Applies To: 1997 Prelude Type SH – Thru VIN JHMBB6 . . . VC007624

March 17, 1997

ATTS Light On / DTC 78: Vehicle Inventory Update

ATTS CONTROL UNIT
P/N 48310-P5P-003 = Replace
or
P/N 48310-P5P-013 = OK

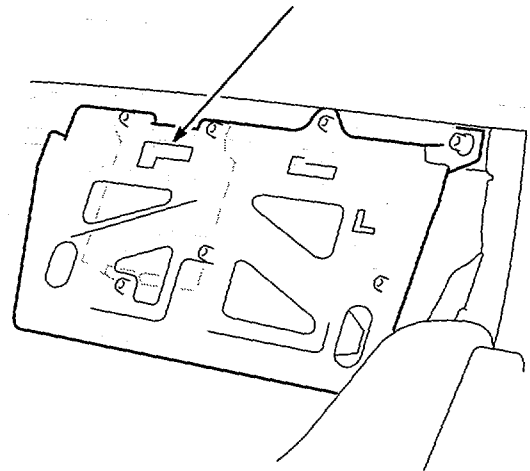
1. Remove the passenger's side door sill molding and kick panel (see service manual page 20-41).
2. Pull back the carpeting. Read the part number of the ATTS control unit through the hole in the upper left corner of the ECM cover.

- If the part number is 48310-P5P-013, it is an updated unit. Reinstall all removed parts, and return the vehicle to the customer.
- If the part number is 48310-P5P-003, it is not an updated unit. Continue to **Control Unit Replacement**.

Control Unit Replacement

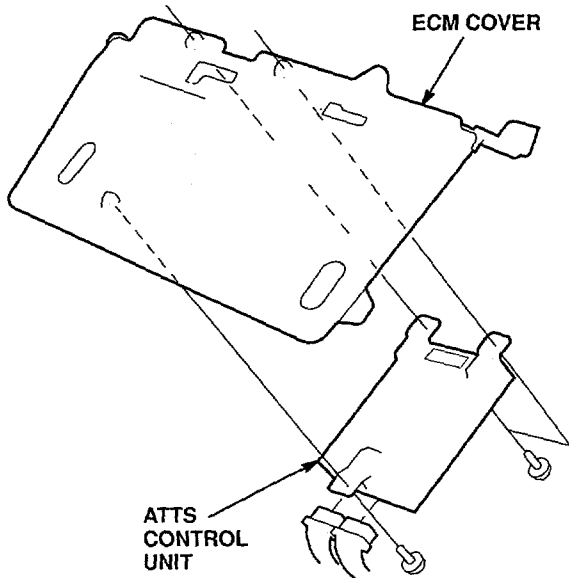
1. Make sure you have the anti-theft code for the audio system. Record the customer's radio station presets.
2. Disconnect the cable from the battery negative terminal.
3. Remove the four ECM cover mounting nuts. Lift the cover.
4. Disconnect the two electrical connectors from the ATTS control unit.

5. Remove the ATTS control unit from the ECM cover (three bolts).
6. Install the new ATTS control unit (see PARTS INFORMATION) with the original bolts. Reinstall the ECM cover.
7. Put the carpet back in place. Install the kick panel and door sill molding.
8. Reconnect the cable to the battery negative terminal.
9. Enter the anti-theft code in the audio system. Enter the customer's radio station presets. Set the clock.
10. Jump the SCS service check connector, and look for any stored Diagnostic Trouble Codes (see service manual page 15-14).
